Exponent "Protocol for Evidence" Rev. A; Figure 1 "Reported Location of Charges"

CPUC 7/15/14

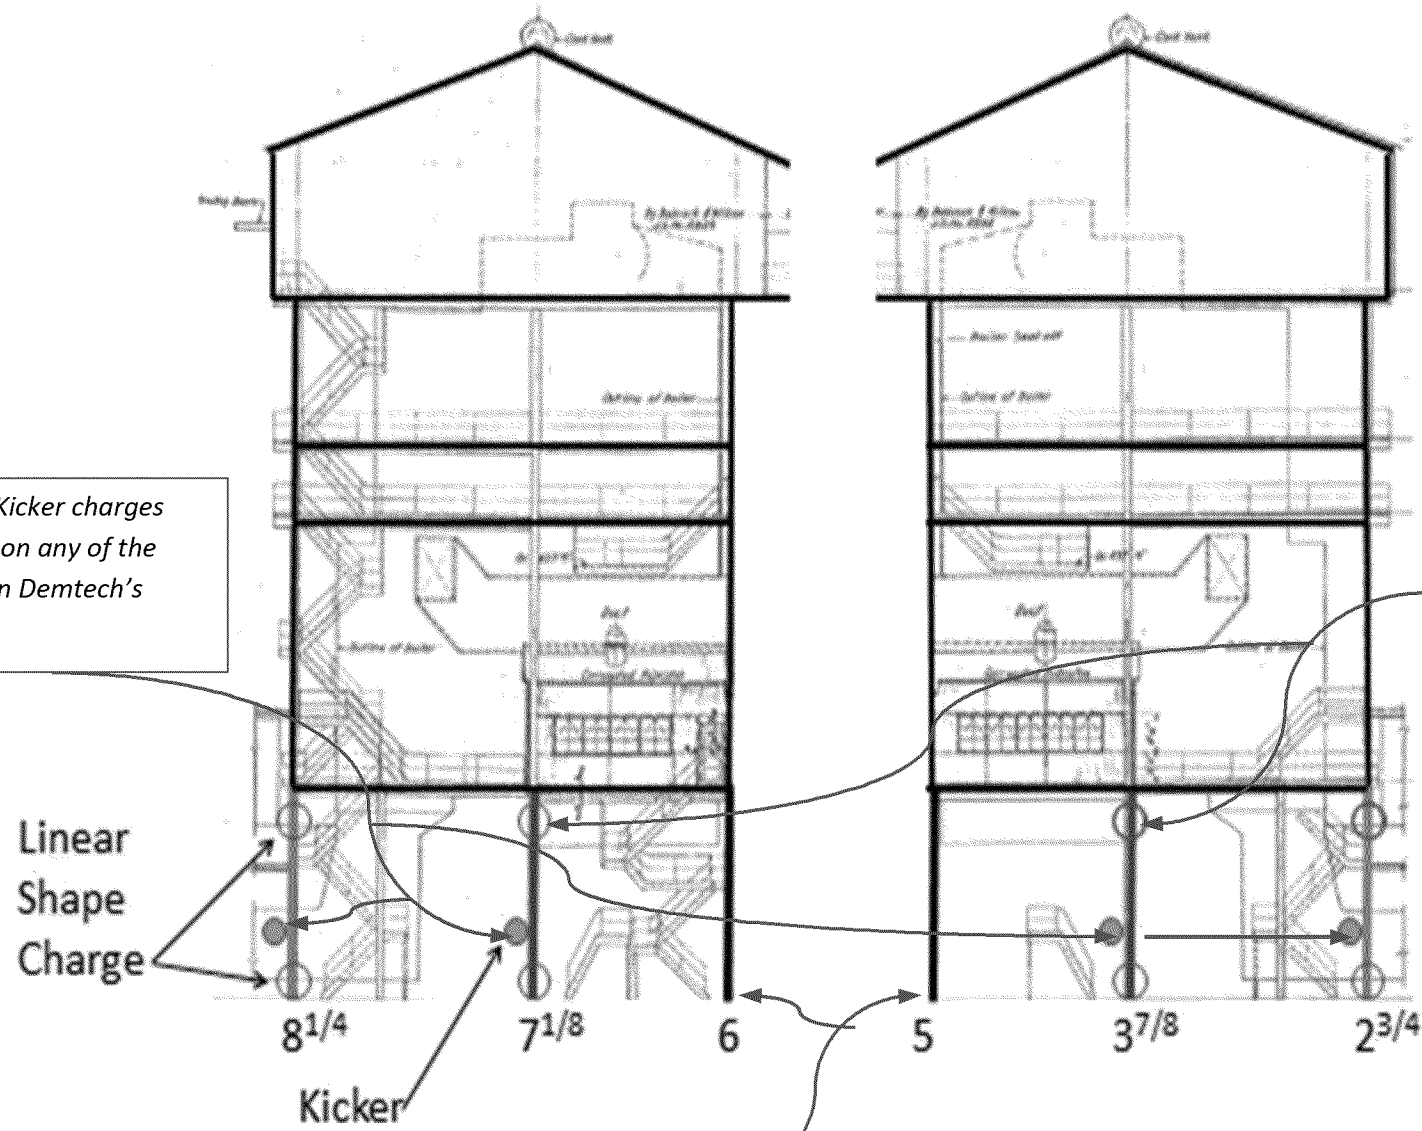
CPUC Comment: Kicker charges are not indicated on any of the columns shown on Demtech's Demo Diagram

CPUC Comment: The location of the upper LSC on columns 7-1/8 and 3-7/8 (second row) are shown at the middle (lower) elevation on Demtech's Demo Diagram.

CPUC Comment; An LSC is not shown on column's 5 & 6 of this diagram (third row). However, it is shown at the base of these columns on Demtech's Demo Diagram.
